LITTLE GOOSE LOCK AND DAM REMOVABLE SPILLWAY WEIR

VALUE ENGINEERING REPORT

Little Goose Lock and Dam Starbuck, Washington

VALUE ENGINEERING STUDY July 2007

VE-3 BOAT BARRIER

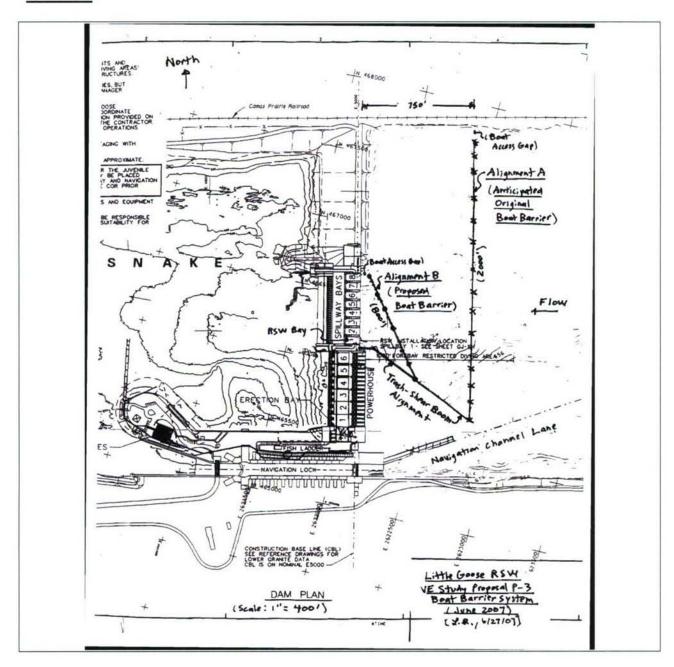
A boat barrier design associated with the Little Goose RSW has not yet been completed. However, this feature is currently shown as an optional item in the 60-percent plans and specifications package. Division 35 specifications call for a boat barrier system for Little Goose as associated with the RSW installation and is the same technical specification used recently for Ice Harbor. The current plan is to pattern the layout of the boat barrier concept after the recently awarded Ice Harbor RSW boat barrier design. The Ice Harbor boat barrier system, with a total length of about 1,600 feet, is aligned parallel to the dam and located about 900 feet upstream of the RSW. The system consists of a series of shallow draft floating drums connected by a cable arrangement held in place by a system of cables and anchors. It spans parallel to the dam and extends across the width of the river, excluding the navigation channel lane along the north shoreline and a small boat access gap near the south shoreline. Using the same layout criteria used at Ice Harbor, the boom at Little Goose would need to be approximately 2,000 feet long. See sketch "Alignment A" that illustrates the anticipated layout based on the recently awarded boat barrier at Ice Harbor.

Little Goose installed a "debris boom" several years ago that helps to deflect debris away from the powerhouse. The intent of the debris boom was to reduce floating debris from accumulating upstream of the powerhouse and reduce the amount of material that frequently jammed the orifices in the fish collection system. The debris boom has very high capacity bottom anchors and cables, designed to be restrained under debris, wind, and wave loads. The boom system allows the opportunity to be an anchor point for the proposed boat barrier on the south end, versus having to install additional mass concrete anchors to the river bottom. The proposed design would connect the south end of the boat barrier boom at the mid-point of the existing trash-shear boom and would utilize an existing primary anchor to secure the south end of the boat barrier. The boat barrier boom would extend northwest (off-parallel to the dam) approximately 800 feet and would secure either to the river bottom or to the dam. See sketch "Alignment B" that illustrates the proposed layout.

The boom will be located closer to the RSW (200-feet versus 750-feet), but for a shallow draft boom design, it should not have any negative impacts for the performance of the RSW/spillway as it relates to fish, debris, or other project related performance objectives.
